Levy Nuclear Plant/PEF
SAJ-2008-00490 (IP-GAH)
Response #4 to Corps Position Letter dated June 23, 2011

Levy Nuclear Plant Units 1 and 2
Response #4 to Corps Position Letter for USACE-SAJ-2008-00490, dated June 23, 2011

Raw Water System
FIGURE 9.2-201

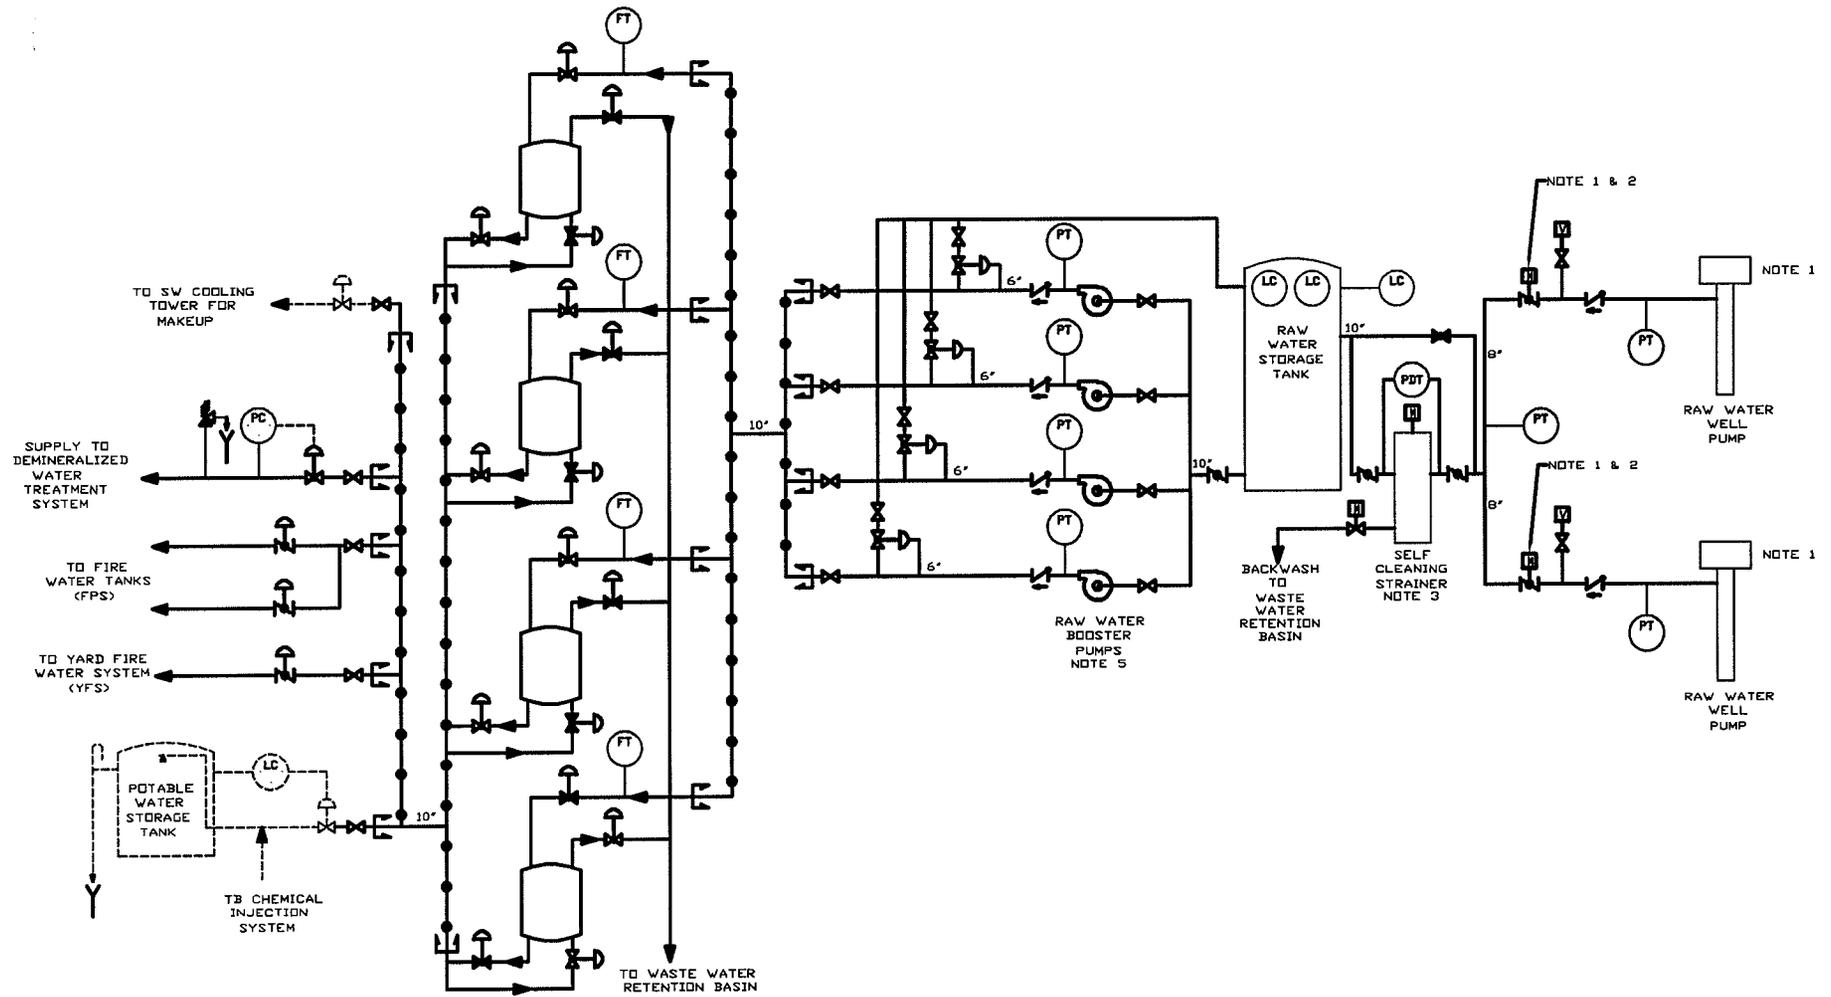
The DEIS states that up to 2092.9 acres of wetlands could be adversely affected over the course of the 60 years that ground water is pumped to support the LNP project. Provide an analysis of other alternative sources of water to support the LNP project.

The fresh water supply for the Levy Nuclear Plant is designed to be fresh water from groundwater wells. As depicted on Figure 9.2-201, Rev. 3, in the FSAR (Appendix 1), the supply is from four (4) groundwater wells (two per nuclear unit) that deliver water to four (4) of the nuclear plant units' systems as follows:

The source of water for the LNP site RWS freshwater subsystem is the groundwater aquifer. There are four wells that supply the freshwater. Each well contains a raw water well pump, two for each nuclear plant unit. In addition, the RWS system consists of Unit 1 and Unit 2 pump houses, self-cleaning strainers, and raw water storage tanks. Each pump house contains four raw water booster pumps and appropriate instrumentation and controls.
